# Vickery Extension Project Surface Water Assessment Independent Review

Reference: R.B23500.001.00.Review Report.docx  
Date: November 2018  
Confidential

BMT was commissioned by the NSW Department of Environment and Planning to complete an independent review of the surface water assessment completed by Advisian as part of the Environmental Impact Statement for the Vickery Extension Project. The review was conducted by Martin Giles, a Senior Principal with BMT.

Figure 2-1 Water Quality Sampling Locations (Figure 5-1 of Surface Water Assessment)

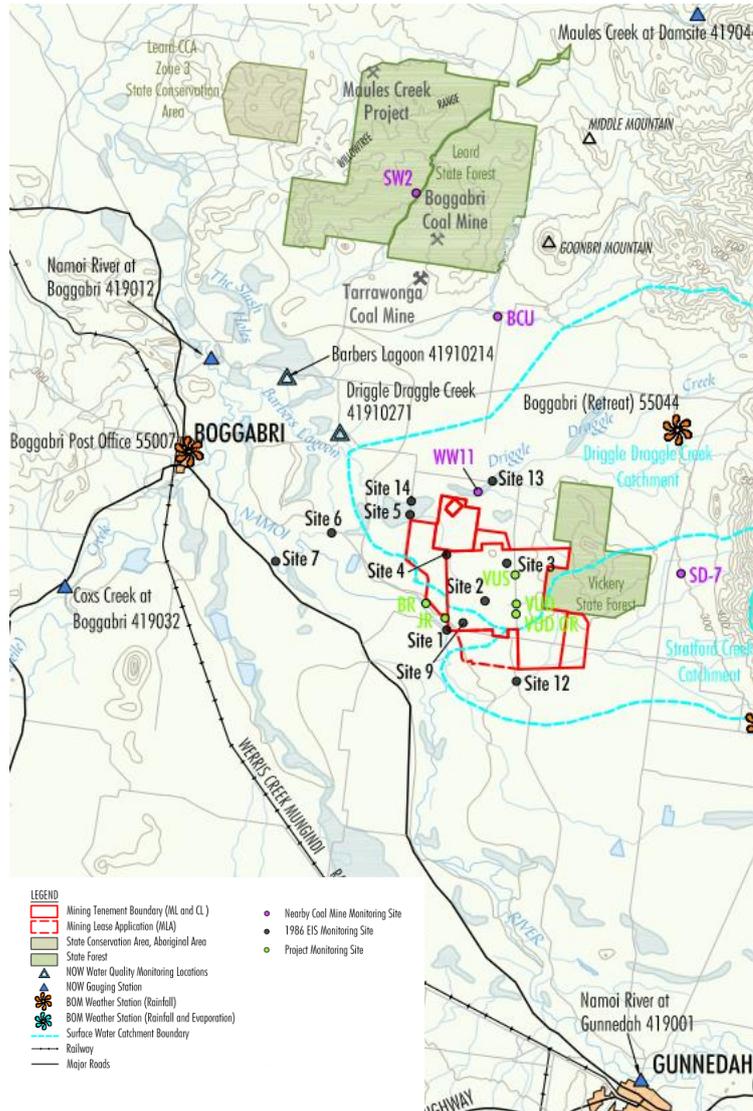
The water quality sampling data presented in the Surface Water Assessment is of limited value, only providing an overview of regional stream characteristics for a narrow range of parameters and very limited data for the watercourses that could receive runoff from mining activities.

For example, the values quoted from the 1986 are over 30 years old. Although it is beneficial to have records for a long period, an isolated set of data of such age is of limited use.

Further, it would appear that the values presented in the Surface Water Assessment reflect the arithmetic average of the results rather than median values. When considering water quality data, it is preferable to use median data to avoid outlier values. In the case of the 1986 data, the use of arithmetic averaging results in the high Electrical Conductivity value recorded at the 11 sites being skewed by the 2,489  $\mu\text{S}/\text{cm}$  value recorded at Site 9. In comparison, the second largest reading was 517  $\mu\text{S}/\text{cm}$ . The median value for the 11 sites is 185  $\mu\text{S}/\text{cm}$  rather than the 456  $\mu\text{S}/\text{cm}$  nominated in the assessment. Based on the median value, the Electrical Conductivity at the sites sampled in 1986 is typically within the ANZECC trigger value.

In addition, many of the sites for which data is presented (for example BCU, SW2, Maules Creek at Damsite) are located well outside the catchments that drain through the site. While they provide an indication of the general quality of water in the region, the results cannot be used to assess the quality of the water in the watercourses downstream of the mine.

The value of data collected at other sites is also questionable as some of the project monitoring sites will ultimately be removed by mining activities.

To allow trigger values to be defined, it will be necessary for the proponent to:

- Identify water quality sampling sites, both upstream (where practicable) and downstream of points of discharge from sediment basins, and further downstream to the Namoi River (potentially more sites than identified in the report);
- Define a water quality monitoring program (including at least pH, Electrical Conductivity, Total Suspended Solids, Total alkalinity/acidity, Sulphate, Aluminium, Arsenic, Molybdenum, and Selenium);
- Complete regular monitoring; and
- Define existing water quality and appropriate trigger values based on accepted methodologies.
